<b>JRPP No:</b>	<b>2011SYE062</b>
<b>DA No:</b>	<b>DA205/11</b>
<b>PROPOSED DEVELOPMENT</b>	<b>Demolition of existing buildings and structures, erection of a 31 storey commercial development with 5 levels of basement parking at 177-199 Pacific Highway North Sydney</b>
<b>APPLICANT:</b>	<b>Winten Property Group</b>
<b>REPORT BY:</b>	<b>Geoff Mossemeneer, Executive Planner, North Sydney Council</b>

## Assessment Report and Recommendation

PROPOSED PLAN

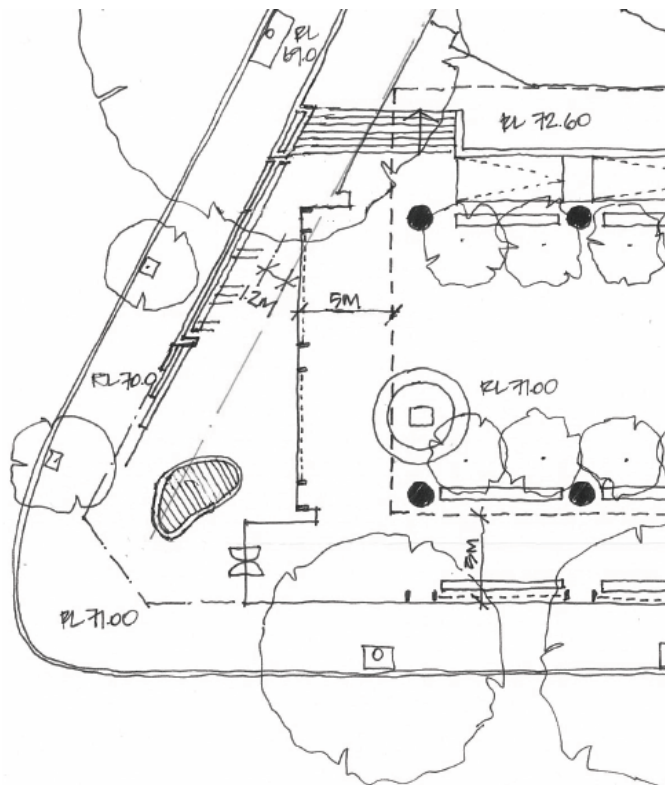
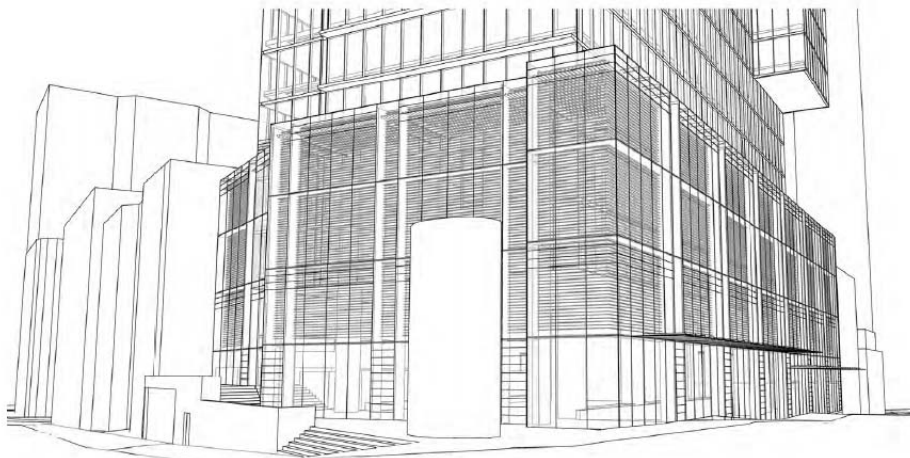
*The Panel had concern about the tightness of the street corner of the podium and its acute angle. The Panel suggests a chamfer or splay be provided perhaps at right angles to Pacific Highway to a depth of about 5m that could relate to the 5m protruding element on the tower above. This would also provide for a more comfortable width on the footpath at the corner.*

*The Panel had concern with the large ventilation shaft at the corner within the podium. The shaft needs careful treatment with its finishes so that it does not dominate the internal space or what can be seen from outside. The Panel questioned whether the shaft could be setback further from the intersection (near the NW corner of the tower). It was also suggested that the use of timber elsewhere in the "garden", perhaps on the ceiling, would serve to unify the space, which has quite a few finishes. While it is acknowledged that the space should be rich in character, more cohesiveness would add to the quality of the space.*

*The Panel discussed the response of the applicant with regard to the further setback of the podium at the corner of Berry Street and the Highway. The Panel favoured the option where the glass was 5m from the tower element provided there was no encroachment on the Berry Street special area (the area within 8m of the Berry Street kerb).*

*The Panel considered that the 8m strip should be at grade consistent with the existing footpath level with no retaining walls, level changes or stairs within the strip. Any stairs required to access the garden plaza should be clear of the Berry Street Special Area. The Panel did not support the ventilation shaft being located outside the building.*

*The Panel also discussed a possible 1m setback to the Pacific Highway as concerns had been raised about the existing footpath width on the Highway (about 3.6m with street trees narrowing the footpath). The Panel felt that most of the occupants of the tower would travel south to the train station and the widening was not necessary. It was also considered that the podium should be built to the street to be in keeping with the approved cantilevered section of the tower built to the boundary.*

The applicant responded to the comments of the DEP with amended sketches incorporated amendments to the corner of the podium and ventilation shaft. The preferred sketch is shown below:

This proposal does protrude 1.2m into the Special Area setback. Maintaining the consistent 5m atrium on both Berry Street and Pacific Highway provides significant architectural merit through clarity of the scale and proportion of these spaces.

The small protrusion, when averaged against the overall length of the Berry Street frontage, is a minor intrusion considering 50% of the facade is setback significantly more than the required 8m.

The riser location protrudes a similar distance into the setback to create a consistent alignment with the podium and enable sufficient circulation width around the riser.

This scheme is our preferred resolution to the DEP's concerns.

The DEP comments are supported, the changes are such that they can be addressed by condition without the need for amended plans.
